**ADDENDUM NO. 4**

**COMPTON AVE BRIDGE OVER UPRR REPLACEMENT**

DATE: **4/9/26**

LETTING NUMBER: **8795**

# UPRR 3rd PARTY CONSTRUCTION ZONES

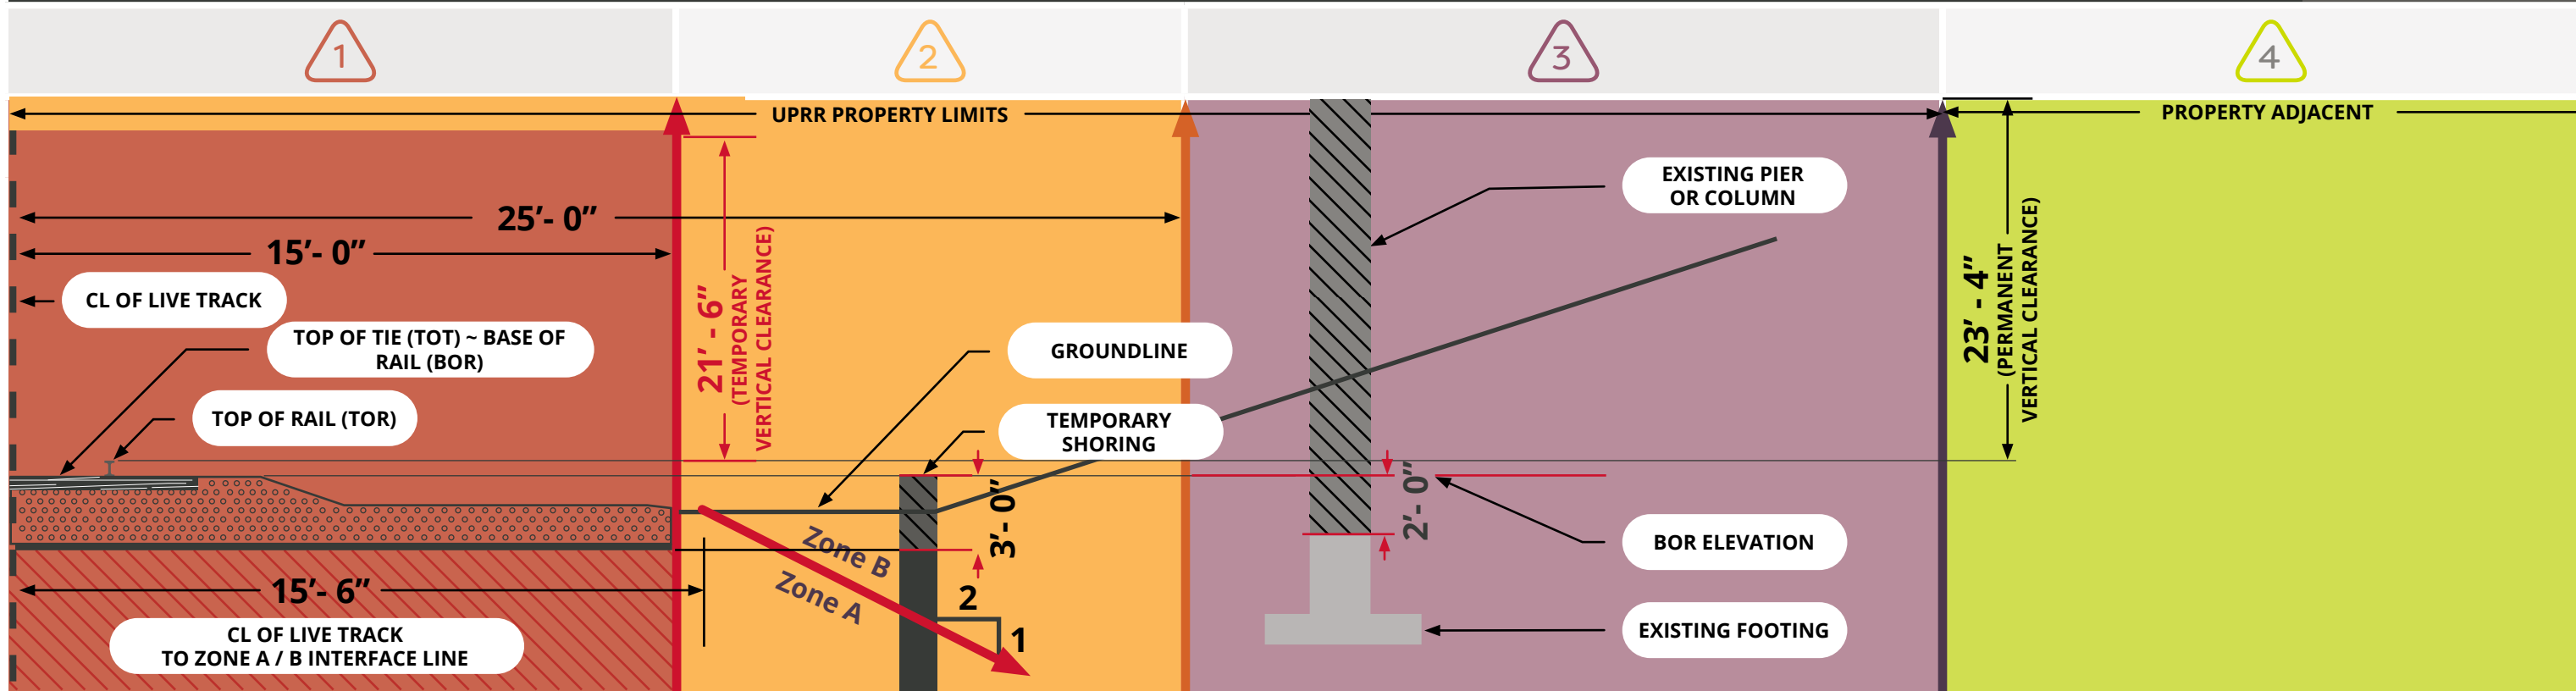
**A:** When asked this question, the UPRR representative provided UPRR's 3<sup>rd</sup> Party Construction Zone guidelines (attached to this addendum) and advised contractors to refer to flagging requirements when working adjacent to active lines. The stub track has not been used in several decades, and trains cannot operate on it in its current condition, however UPRR retains right to run trains on this track at any time. Contractors should use their best judgement when preparing their bids.

- ASSUME THAT NO TRACK OUTAGE HAS BEEN GRANTED FOR WORK PROTECTION
- APPLIES TO AT GRADE AND **OVERPASS GRADE SEPARATIONS**. OTHER CRITERIA MAY APPLY FOR **UNDERPASS GRADE SEPARATIONS**.
- AERIAL LIMIT OF THESE ZONES EXTEND INDEFINITELY AND DOES NOT END AT VERTICAL CLEARANCE

- No obstructions shall be placed in zone
- Walkway to remain clear from hazards
- **No shoring installation** within zone without UPRR Engineering approval
- No excavation zone (noted by cross-hatching)

- RR flagger required for any person, equipment or activities within this zone, including work on overhead structure
- NO storage of equipment, material, etc.

- RR flagger possibly required for equipment moves within this zone (dependent upon intended use of equipment, TBD by EC firm)
